REZN-24-8

# Rezoning Conditions of Approval

1. **Project Name:** Inspiration SIP
2. **Location:** 43.0074, -89.4016
3. **Permit Request No.:** RZ-2552-24
4. **Ordinance No.:** 2024-O-20
5. **Decision Date:** June 18, 2024
6. **Legal Description:** Lot 1 of CSM13827
7. **Current Zoning Districts:** PDD-GIP
8. **Proposed Zoning Districts:** PDD-SIP

Planning & Zoning Comments

SITE PLAN	PROJECT NO. 22281000
	SHEET C120

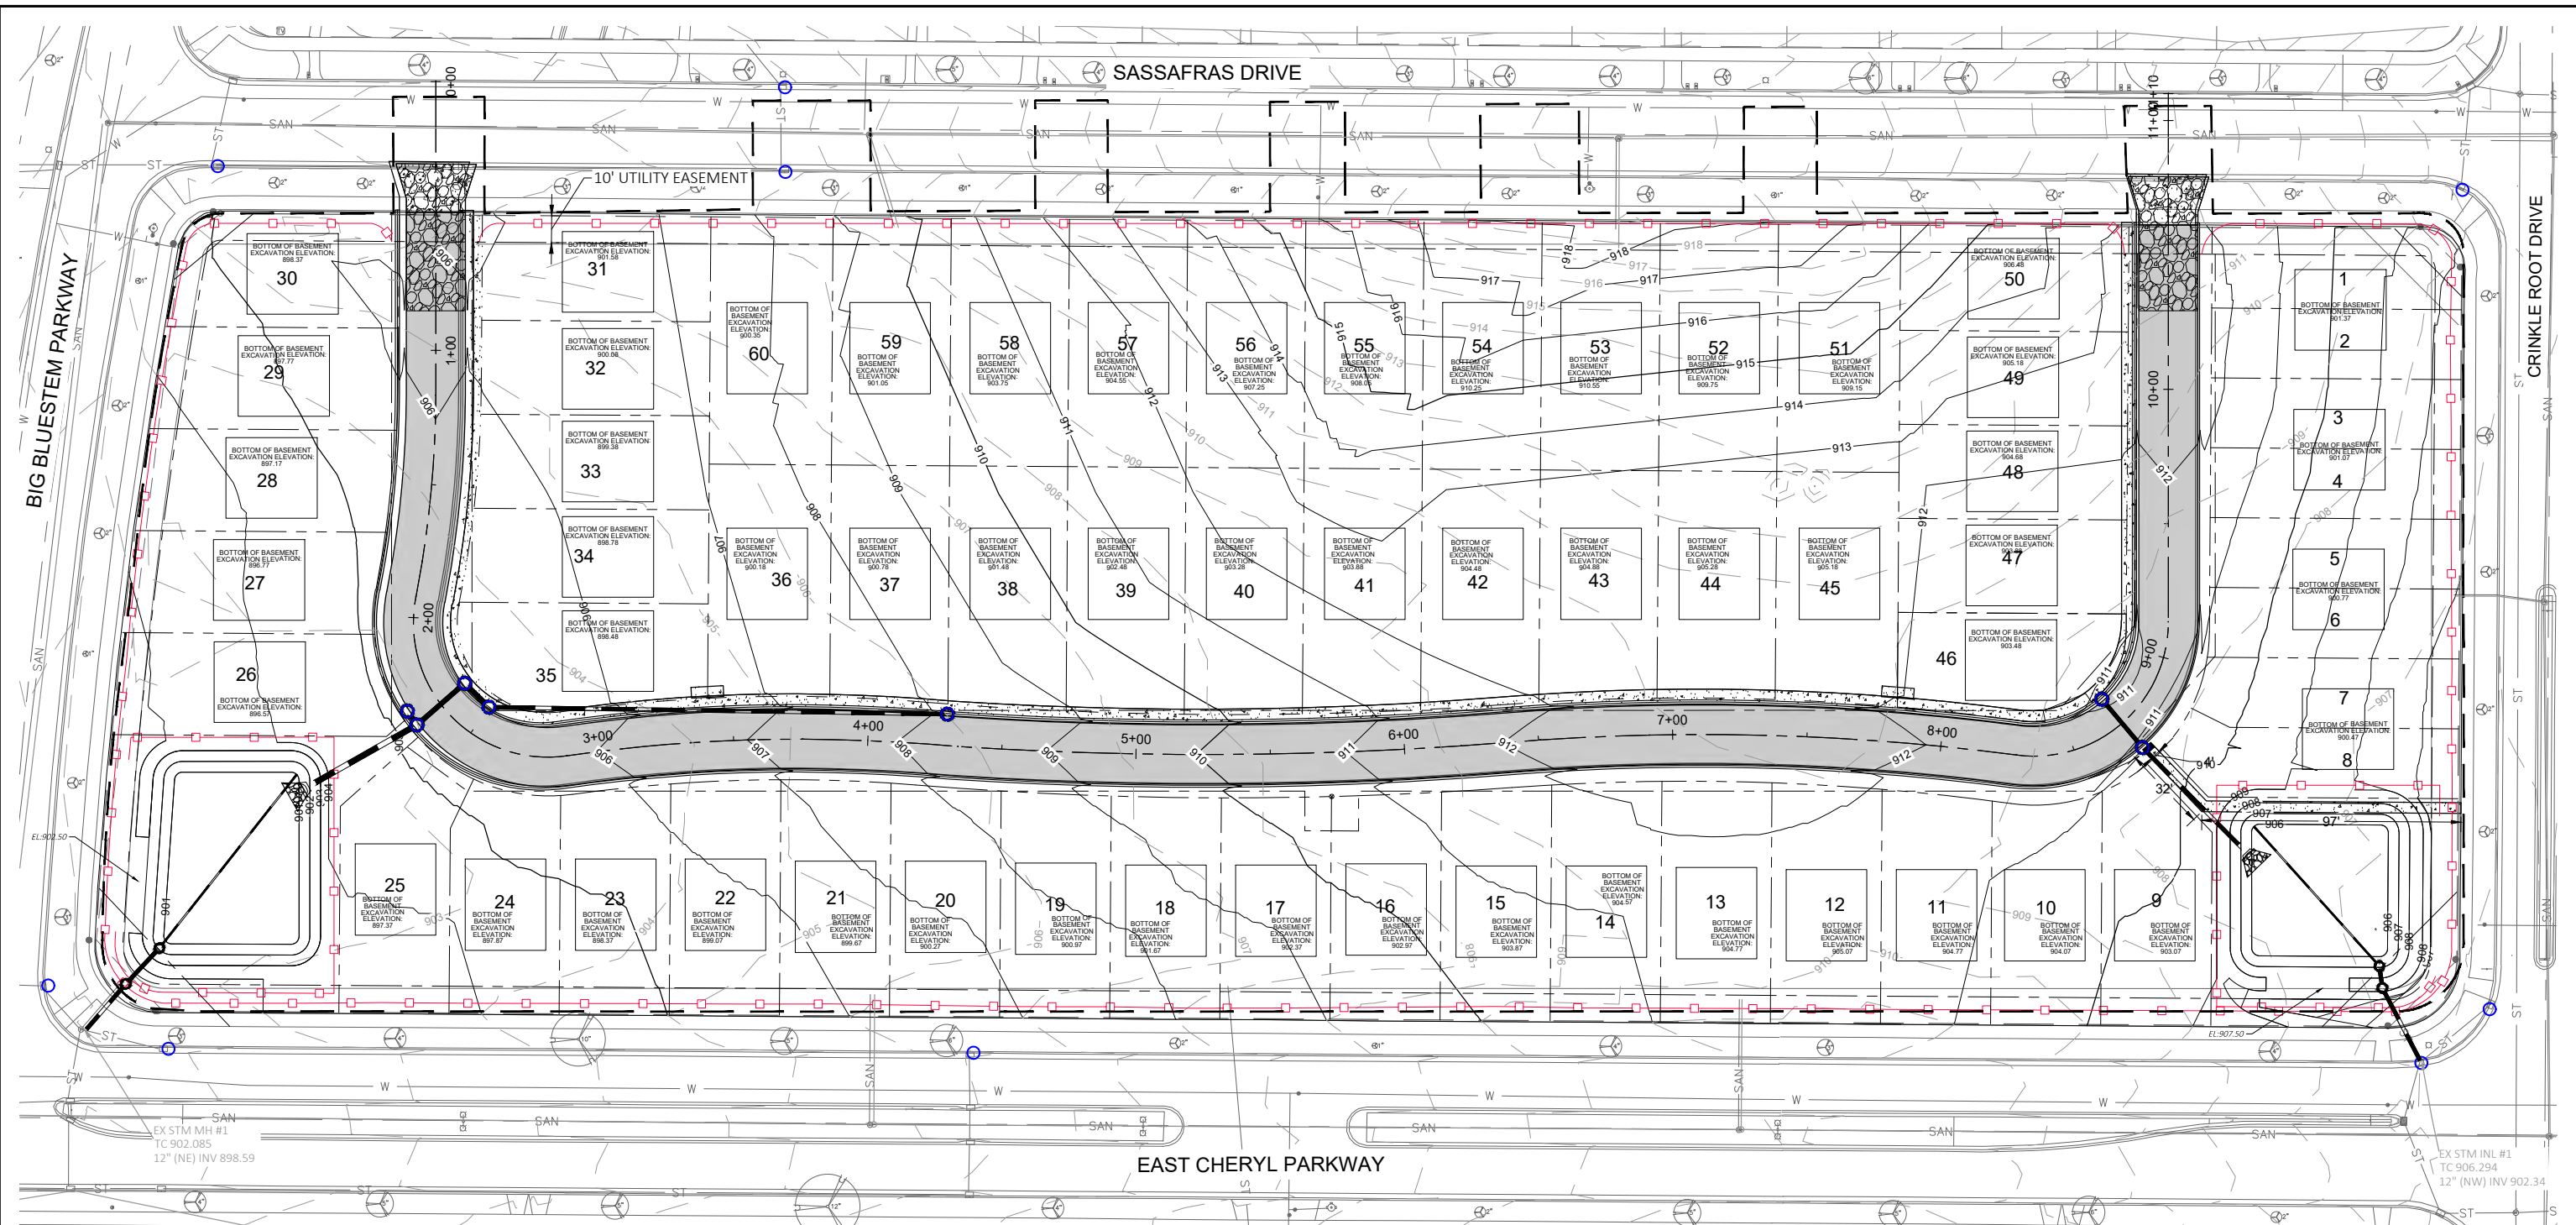
9. Developer should coordinate with USPS on a centralized mode of delivery for mailboxes. **USPS has confirmed two (2) locations as depicted on the Site Plan, sheet C120.**

09 INSPIRATION WAY TYPICAL SECTION  
C501

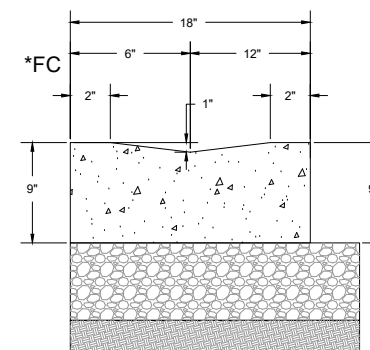
Tracy Foss	May 30, 2024	Open	<ol style="list-style-type: none"> <li>1. A subdivision improvement agreement is required for this development. The existing agreement will need to be amended. <b>Understood.</b></li> <li>2. Developer needs to provide a designated location for US Postal Service Centralized Mode of Delivery. <b>USPS has confirmed two (2) locations as depicted on the Site Plan, sheet C120.</b></li> <li>3. All private roadways shall be constructed of asphalt or concrete and shall provide for subbase and pavement design equal to or greater than that for local public <i>street</i>. <b>Confirmed, see detail 09 on plan sheet C501.</b></li> </ol>
------------	--------------	------	---

SHEET NAME  
TYPICAL HOME LANDSCAPE PLANS  
AND DETAILS

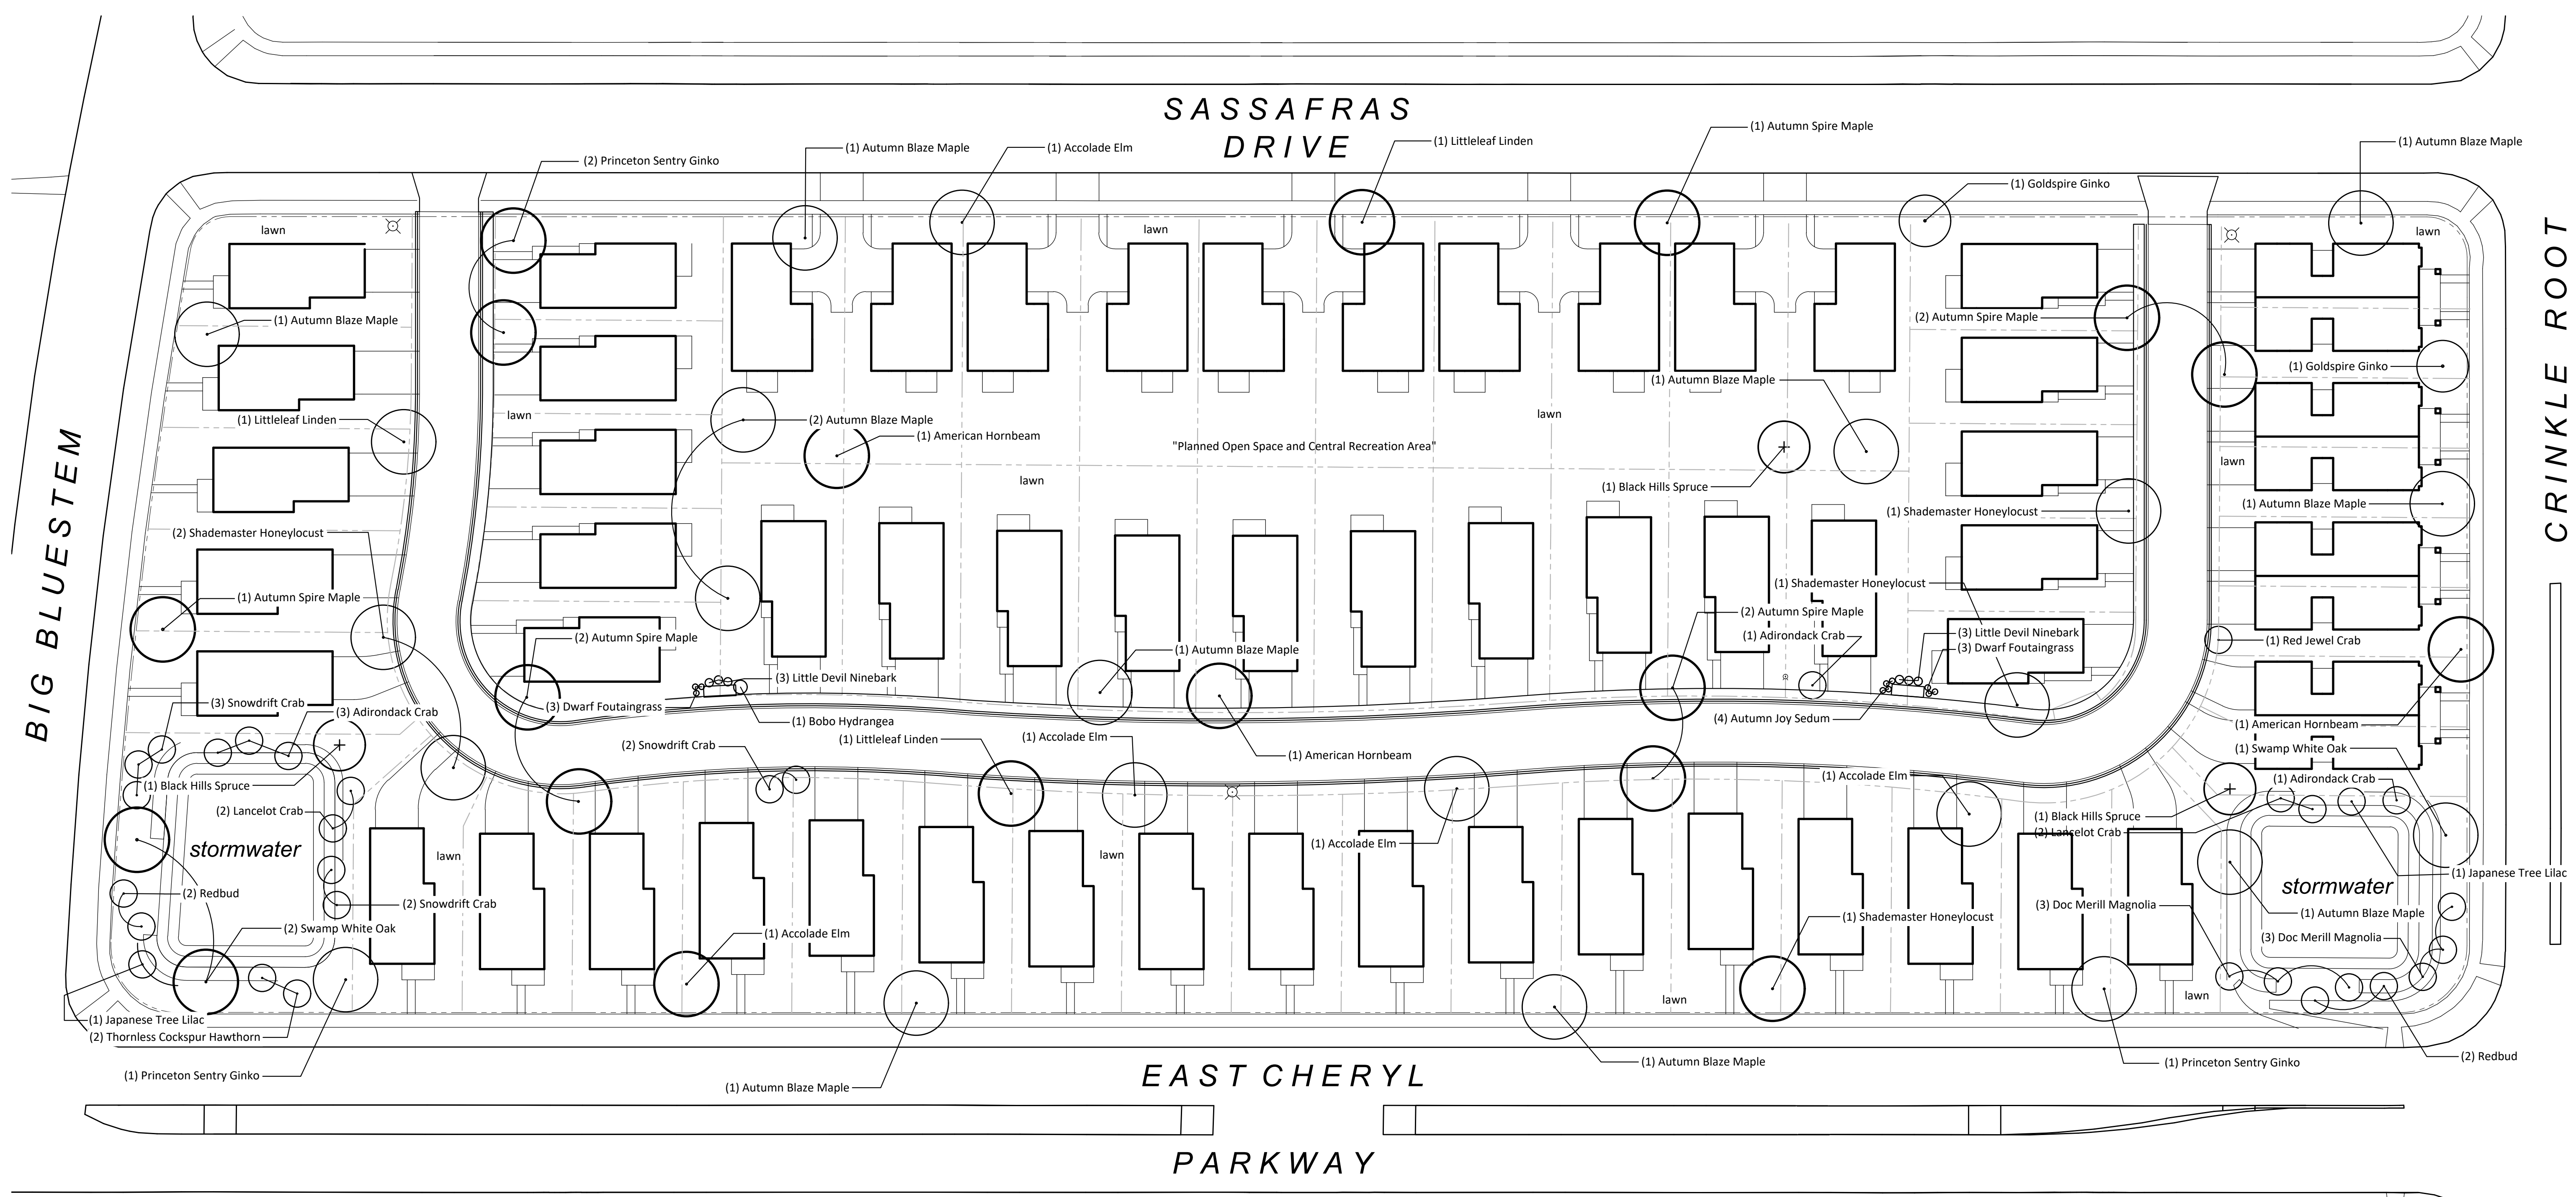
- ix. Who is responsible for the installation of the landscaping - developer (**Sheet L-1.1 and Details 4-7 on Sheet L-1.2**) or the builder (**Sheet L-1.2 and Details 4-6**)? What amount of landscaping is required with the building permit? **Details 1-3 on Sheet L-1.2.**
